View at Symphony Park Apartments

CITY OF LAS VEGAS		DATE:
INTER-OFFICE MEMORANDUM		September 17, 2018
TO: Land Development Services Department of Building & Safety		FROM: Albert Sung, P.E. Flood Control Project Engineer Department of Public Works
SUBJECT:	COPIES TO:	
Drainage Study for:	Kimley-Horn	
View at Symphony Park Apartments		
Cross Streets:	NWC of City Pkwy. & Symphony Park Ave.	Symphony Park Vegas, LLC
File Number:	F:\Depot\DSMemos\DS5034A.doc	Bart Anderson, P.E., DevCo
Parcel Number:	139-34-110-009	
Zoning Action:	SDR-73363 & SUP-73362	
FEMA Flood Zone	YES NO X	
Proposed Storm Drain	YES X NO

Addendum #1 to the Technical Drainage Study for
View at Symphony Park Apartments
(DS5034A)

**RE: *Addendum #1 to the Technical Drainage Study for View at Symphony Park Apartments
(APN:139-34-110-009) (DS5034A)***

McCARRAN AIRPORT RAINFALL AREA

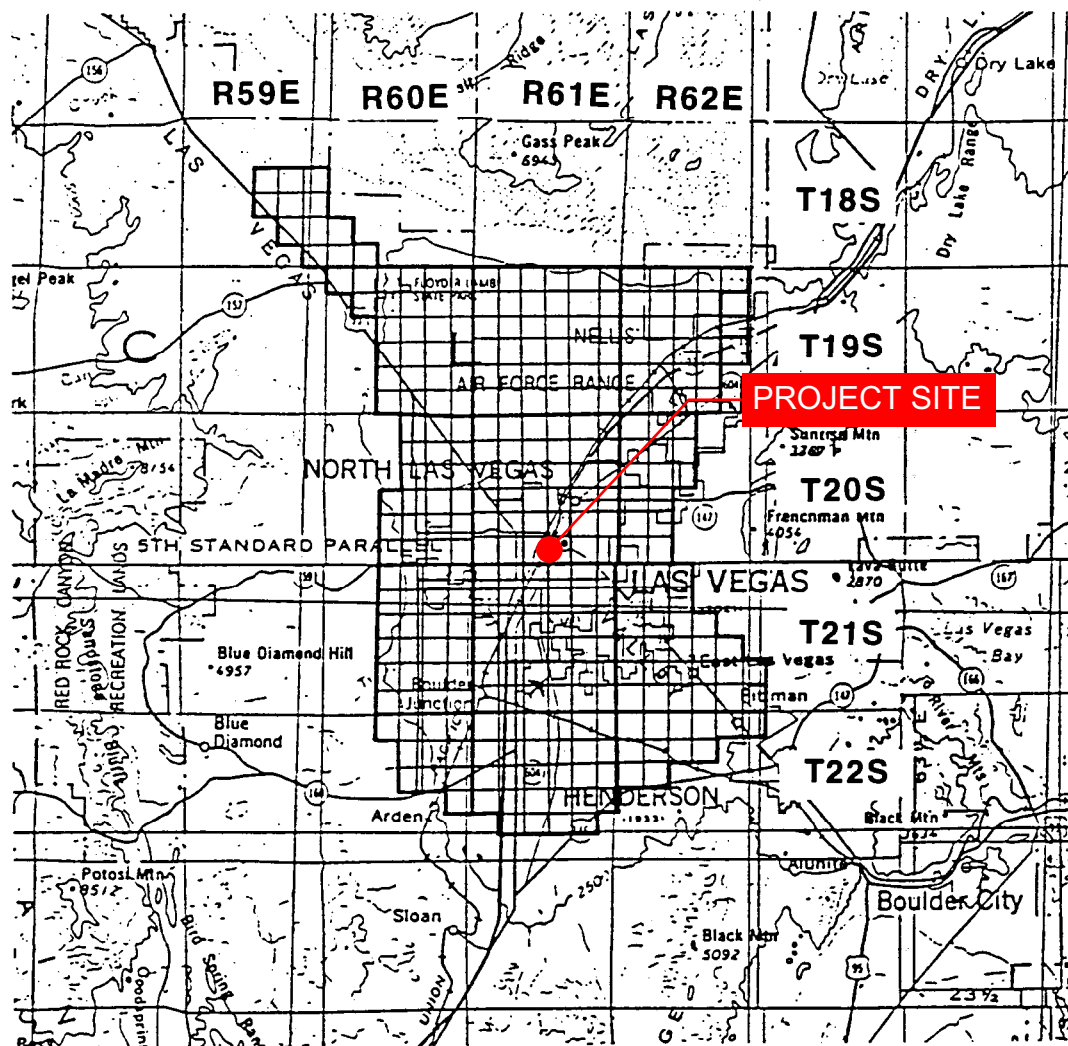
4. **The wrong Township/Range/Section is highlighted on the McCarran Airport Rainfall map, please revise.**

Response: Figure 513 McCarran Airport Rainfall Map has been revised to highlight the correct Township/Range/Section. Refer to **Appendix A**.

Cross Section for HS-3 SYMPHONY PARK Q100 EX COND

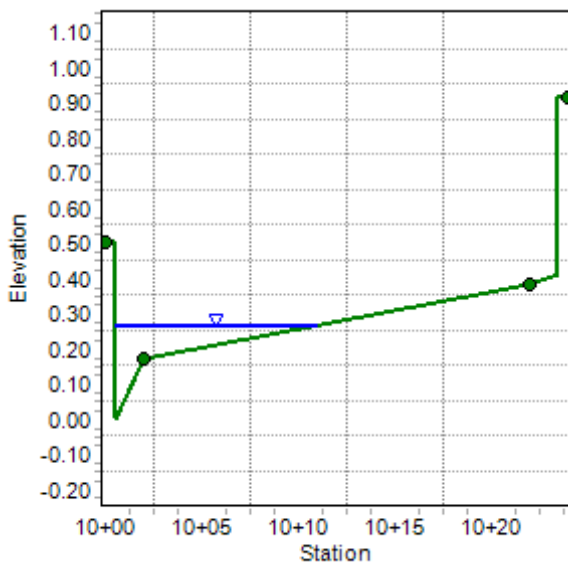
2. **EX-1 The flow depth and velocity shown for the 100-year event for cross section HS-3 does not match the flow master output results provided in the report, revise accordingly.**

Response: The Offsite Hydraulic Summary Table on EX-1 has been updated to reflect the correct output from FlowMaster. Refer to **Appendix B**.

MAJOR STORM CHECK
 $D*V = (0.26)(1.43) = 0.37 < 8$ OK

Cross Section for HS-4 SYMPHONY PARK AVE 10YR PR COND

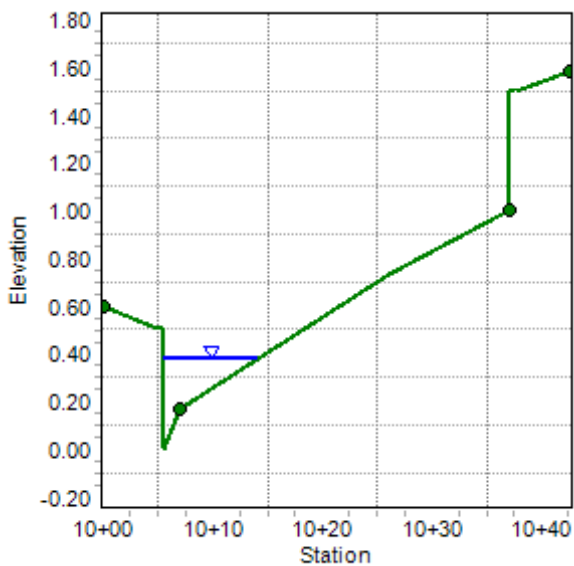
3. **EX-2 The flow depth and velocity shown for the 10-year event for cross section HS-4 and the 100-year event for cross section HS-11 do not match the flow master output results provided in the report, revise the next submittal.**

Response: The Offsite Hydraulic Summary Table on PR-1 has been updated to reflect the correct output from FlowMaster. Refer to **Appendix B**.

$$D*V = (0.38)(1.68) = 0.64 < 6 \quad \text{OK}$$

Cross Section for HS-6A - PROMENADE PLACE 100YR PR COND

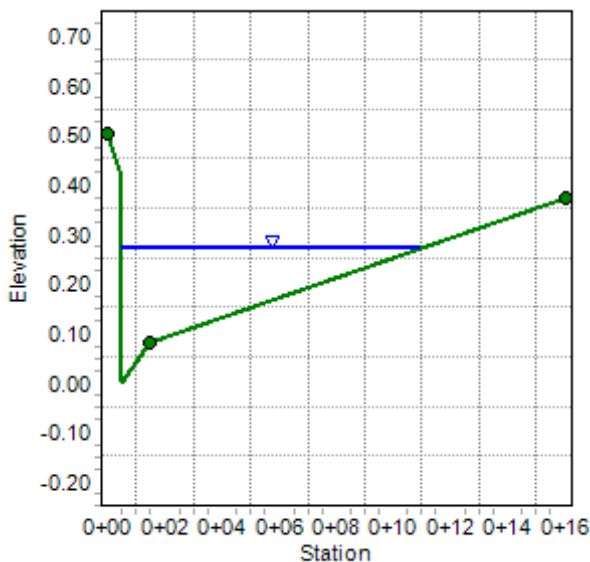
5. The following finish floors do not meet the Regional Flood Control District minimum criteria of twice the Q100 depth of flow up to 18-inches above the water surface (CCRFC Manual Section 304.4E.1) or 6-inch minimum above the highest adjacent top of curb (CCRFC Manual Section 1602 304.4E.1). The following finish floors should be revised or alternate flood protection provided.

Response: The hydraulic sections representative of the areas in question are **HS-11** for the retail at the southeast corner, **HS-6A** for the retail at the southwest corner, and **HS-6B** for the office at the southwest corner. As shown in these cross sections, the Finished Floor elevations are elevated more than twice the depth of flow. The Finished Floors at the south end of the site could not be elevated 6-inches above the highest adjacent top of curb due to accessibility issues into the commercial sites because slopes would be greater than 2 percent. In a telephone conversation with Mr. Sung on September 24, 2018, it was discussed the City requires Finished Floors to be 6-inches above adjacent to of curb but waives this requirement when site constraints and accessibility makes this unfeasible. Further, with the relatively small amount of flow in the adjacent streets at these locations (upstream end of subbasins, but total subbasin flow used), the buildings on the southern end are flood protected from the 100-year design storm while being elevated more than twice the depth of flow. It is respectfully requested that the 6-inches above top curb requirement be waived in this specific case. Refer to **Table 1 – Finished Floor Elevation** Check below for a summary of the worst-case scenarios around all four sides of the project site. Refer to Proposed Conditions Map **PR-1** in **Appendix D** for the location of the Hydraulic Sections. The Hydraulic Sections can be found in **Appendix B**.

FFE CHECK

$$2D = 2(0.27) = 0.54$$

$$\text{RETAIL FFE} = 2042.50$$

$$\text{FL@BLDG} = 2041.69$$

$$\text{FL} + 2D = 2041.69 + 0.54 = 2042.23$$

$$2042.50 > 2042.23 \text{ BLDG}$$

ADEQUATELY PROTECTED OK

GRADING PLAN

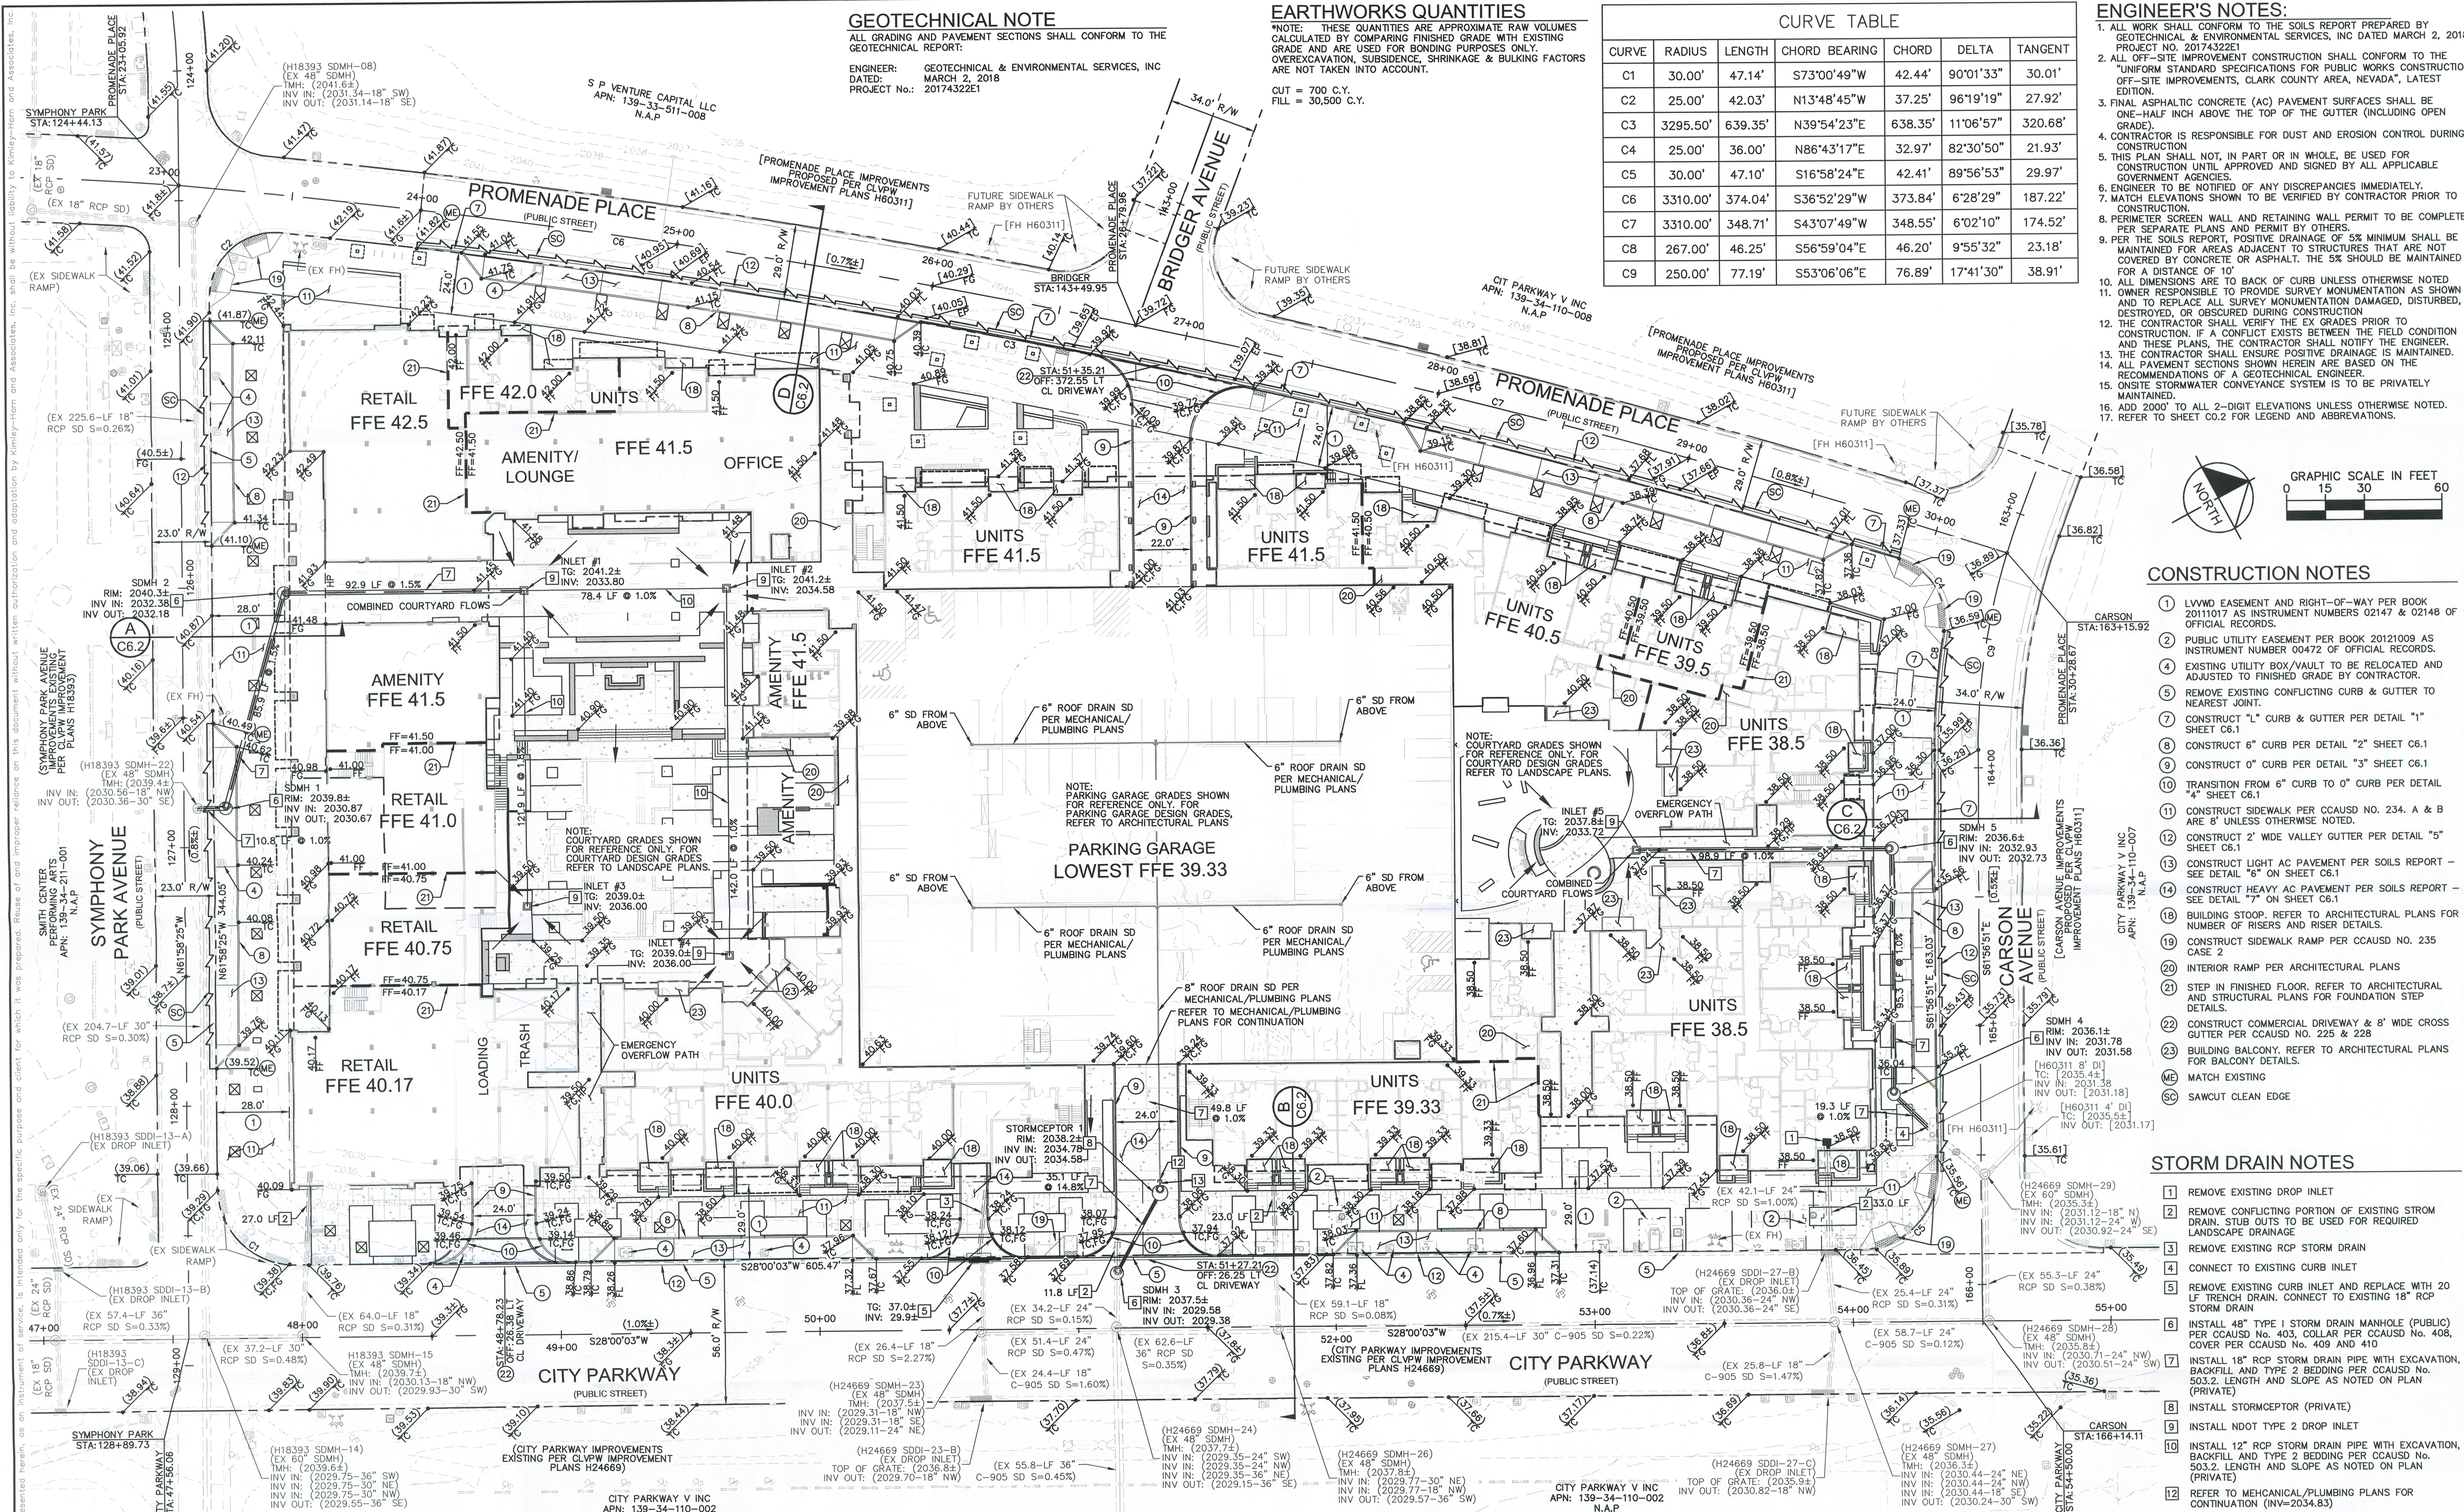
6. The courtyard within the southern portion of the site appears to have problem if Inlet #3 and Inlet #4 are totally clogged during a major storm event. Under such event, water will pond up to elevation 2041.0 before it can drain out to Symphony park Avenue. However, this water surface elevation will flood the adjacent RETAIL buildings to the south and the RESIDENTIAL UNITS to the east which are lower than 2041.0. Address and resolve in the next submittal.

7. Address whether there is an emergency overflow path provided in the courtyard in the northern portion of the site

8. Show the roof drain downspout locations of the PARKING GARAGE and if they connect to any storm drain system in the next submittal.

Response: If Inlet #3 and #4 are clogged, water will pond up to elevation 2039.50 before draining to City Parkway via an emergency overflow path. Grading tags and labels have been added to the grading plan to clearly define the emergency overflow path.

Response: There is an emergency overflow path for the north courtyard that drains to Carson Avenue. Grade tags and labels have been added to the grading plan to clearly define the emergency overflow path.

Response: The roof drain downspout locations and schematic of how they connect to the stormceptor are shown on the grading plan.
